Access Compliance Report

Public Rights-of-Way

(Curb Ramps)

Intersection ID: 15469	Main Street: LATROBE_DR	Cross Street: PRO_AM_DR	Location: NW
ADA ID: B5A7A8583A4D	Ramp Type: PerpDiag	Initial Pass/Fail: Pass	Overall Compliance: No
Codes/Mitigation Info/Possible Solution		Field Measurements/Component Compliance

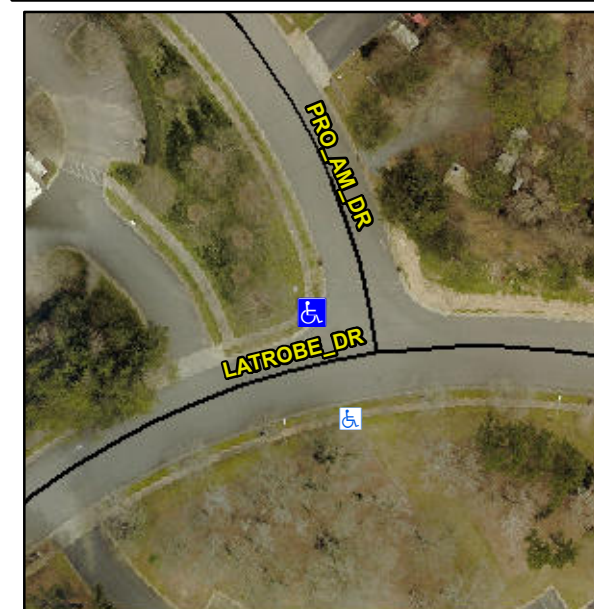
Not Found, R304.5.3, R304.2.1, R304.2.2-Perp, R304.3.2-Para, R304.2.3, R305.1.4, R305.2

Compliance	Description	Data	Compliance	Description	Data
N/A	Ramp Length (in)	47.0	Yes	Ramp Slope (%)	6.5
Yes	Ramp Width (in)	51.5	No	Ramp XSlope (%)	4.3
N/A	Flare Type LT	Sloped	N/A	Flare Type RT	N/A
N/A	Flare Slope LT (%)	2.8	No	Flare Slope RT (%)	12.1
N/A	Flare Traversable LT?	Yes	N/A	Flare Traversable RT?	Yes
No	Landing Length (in)	47.5	Yes	DWS Provided?	Yes
No	Landing Width (in)	45.0	Yes	DWS Contrast?	Yes
No	Landing Slope (%)	2.4	Yes	DWS Length (in)	25.5
No	Landing X Slope (%)	3.0	No	DWS Full Width?	No
N/A	Landing Curb? (Y/N)	No	No	DWS Offset (in)	3.0
N/A	Shared Landing?	No			
Yes	Gutter Ponding?	No	Yes	Gutter Slope (%)	2.5
Yes	Gutter Lip Ht (in)	0.0	Yes	Gutter X Slope (%)	1.2
N/A	Painted X Walk1?	No	N/A	Painted X Walk2?	No
	X Walk 1 Direction	To S		X Walk 2 Direction	To E
N/A	X Walk 1 Width (in)	N/A	N/A	X Walk 2 Width (in)	N/A
	X Walk 1 Slope (%)	2.1		X Walk 2 Slope (%)	1.3
	X Walk 1 X Slope (%)	0.2		X Walk 2 X Slope (%)	2.8

Remove & Replace Curb Ramp With Two New Directional Ramps or Equivalent.
